Application for Licence Amendment

Licence Number	L8578/2011/1
Licence Holder	Regis Resources Limited
ACN	009 174 761
File Number	APP-0031793
Premises	Duketon Gold Project Mining Leases and Miscellaneous Licences M38/114, M38/160, M38/237, M38/250, M38/283, M38/292, M38/302, M38/303, M38/341, M38/343, M38/352, M38/354, M38/407, M38/498, M38/499, M38/500, M38/589, M38/630, M38/802, M38/943, M38/1091, M38/1249, M38/1250, M38/1251, M38/1257, M38/1258, M38/1259, M38/1260, M38/1261, M38/1262, M38/1263, M38/1268, M38/1277, M38/1297, M38/1304, L38/201, L38/202, L38/203, L38/204, L38/216, L38/242 and L38/365 As defined by the Premises maps attached to the Revised Licence
Date of Report	12/03/2026
Decision	Revised licence granted

Figure 3: Single deposition phase for TSF4

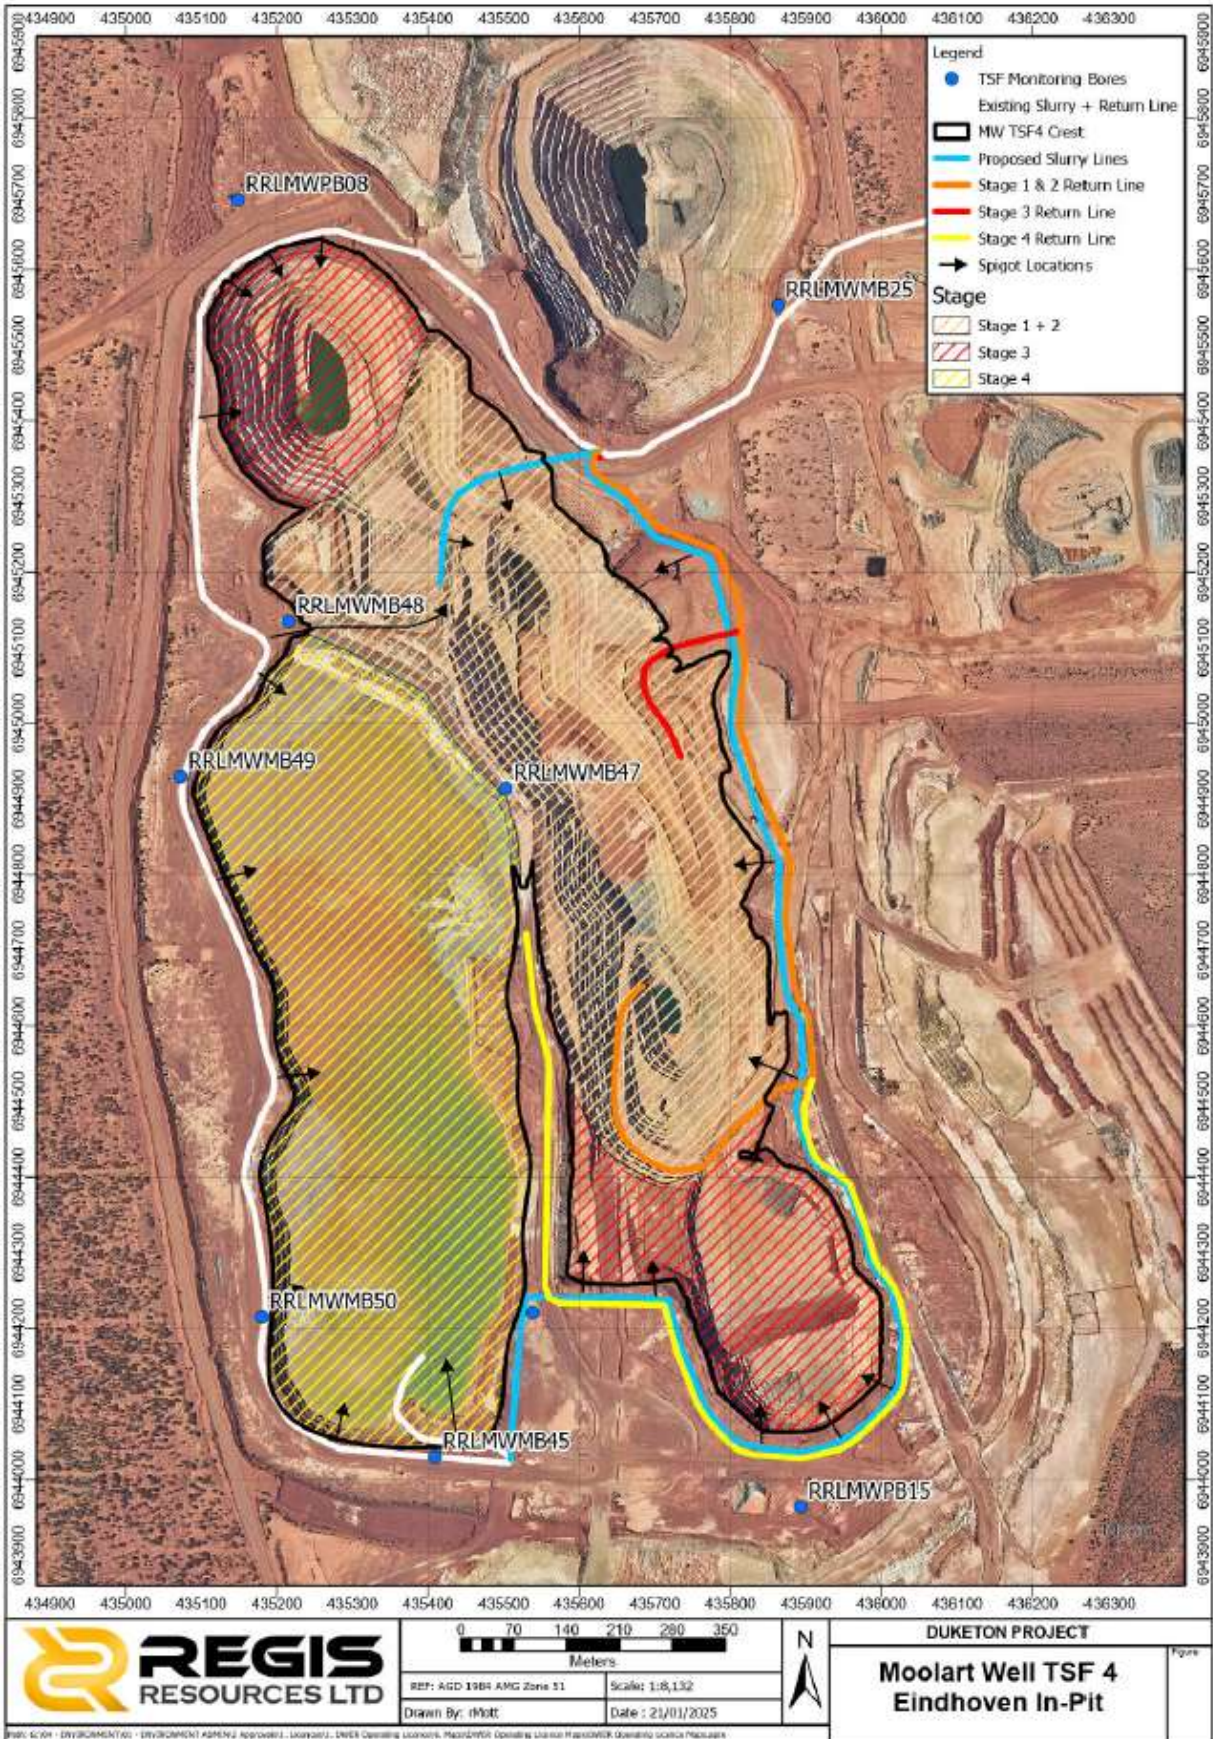
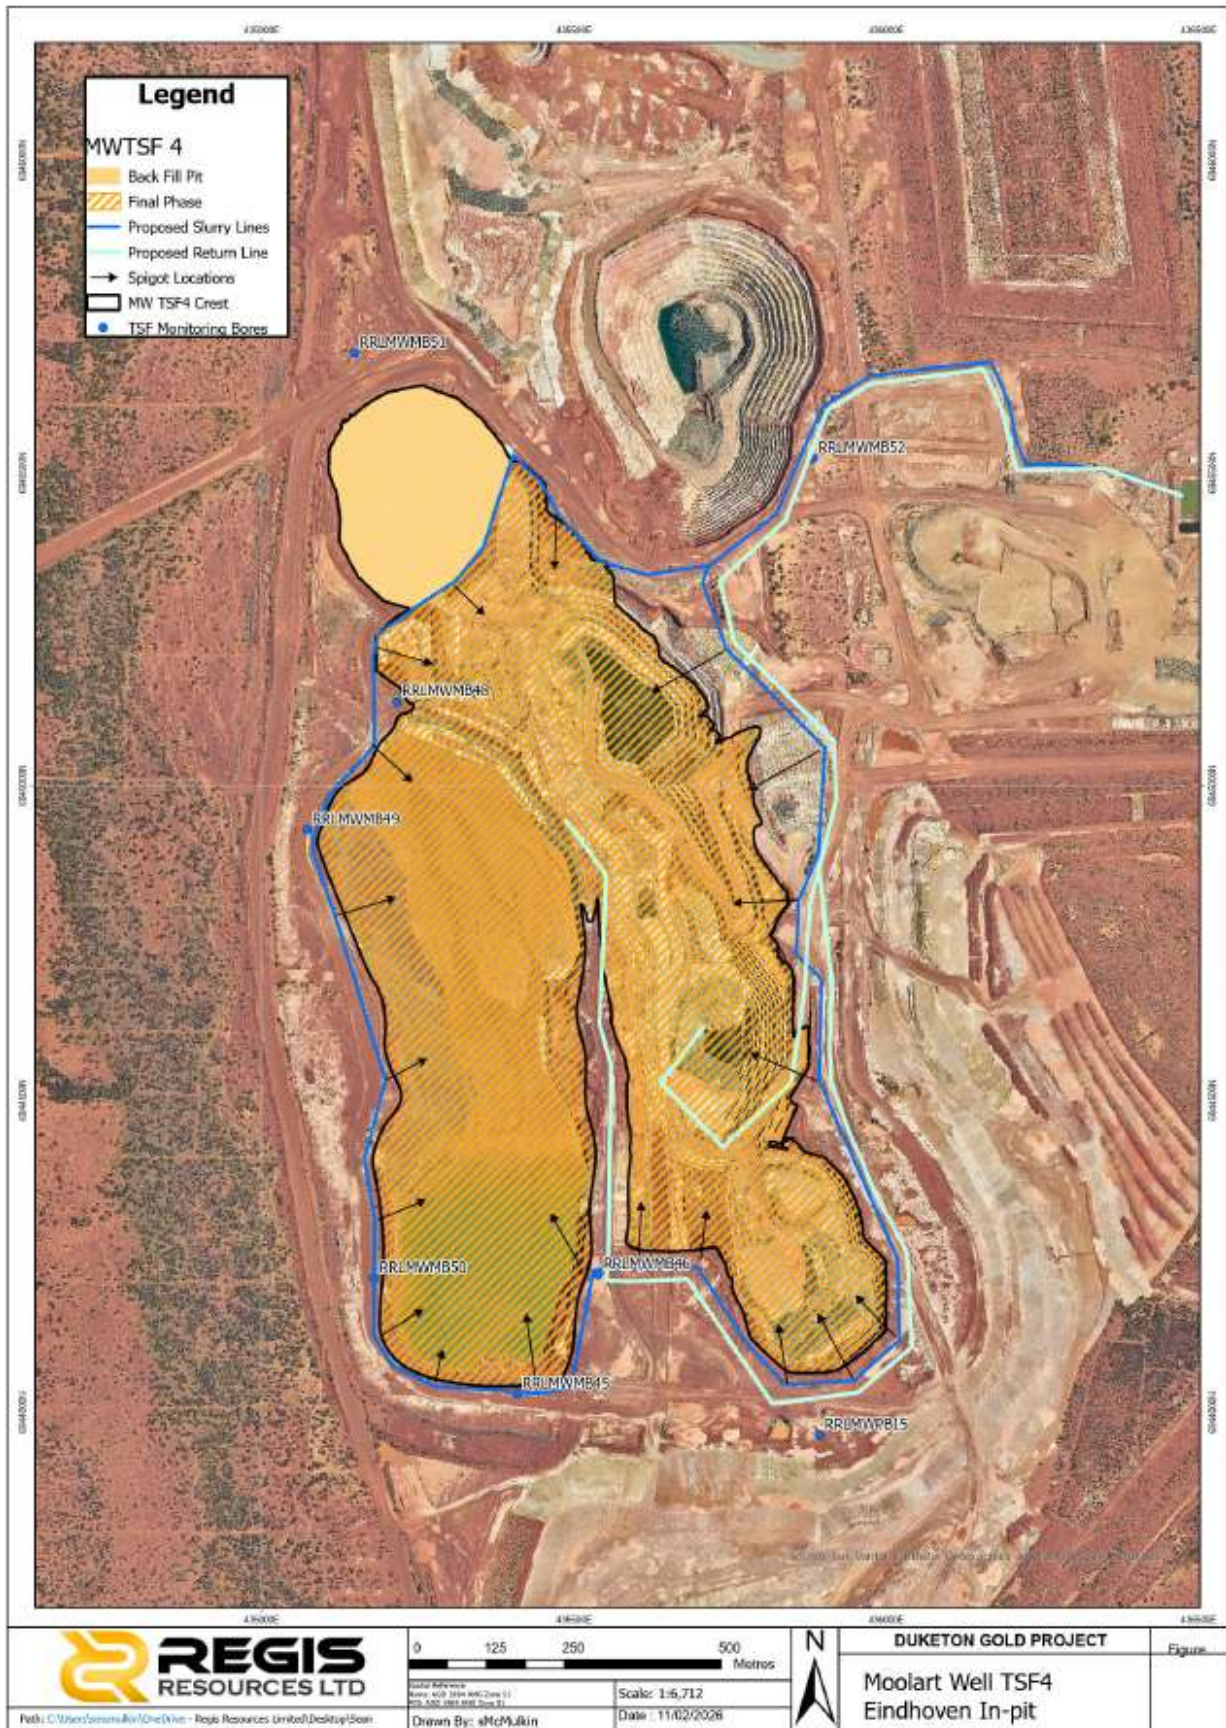
This amendment proposes to make changes to the filling strategy for Moolart Well TSF4. This involves run of mine backfilling of former stages 1 and 2 of and combining stages 3 and 4 (in a single operating phase (Figure 3)). The revised approach balances short-haul waste placement with adequate tailings storage and water recovery capacity. No change is proposed to the overall Category 5 throughput.

1.1 Interpretation	Moved to Definitions table.
Condition 2	Table 1 updated to include Gloster and Ben Hur landfill areas. Quantity limit increased to 25 000 tonnes. Requirement for landfill trenches to be bunded and no more than 50m in length, 10 m wide and 3 m deep added.
Condition 4	Reworded "...tipping area of all landfills..."
Condition 7	Inclusion of backfilling and tailings deposition strategy conditions for MLW TSF4 WWTP ponds named to clarify which operating area they are located (i.e Moolart Well or Garden Well).
Condition 10	Inspection of WWTP pipelines added
Condition 13	Garden Well Tailing Storage Facility 1 stage 4 embankment lift updated to be one 6m lift. Design and construction requirements added for: Secondary crushing circuit at Moolart Well processing plant, Garden Well Paste plant and associated infrastructure, 30 MW Garden Well / Rosemont Power station, New Garden Well wastewater treatment plant, Moolart Well Landfill Expansion, Garden Well Landfill Expansion, Rosemont Landfill Expansion, Ben Hur Landfill and New Gloster landfill. Updates to the 4 stages of construction for MLW TSF4 (4 stages converted to a single stage)
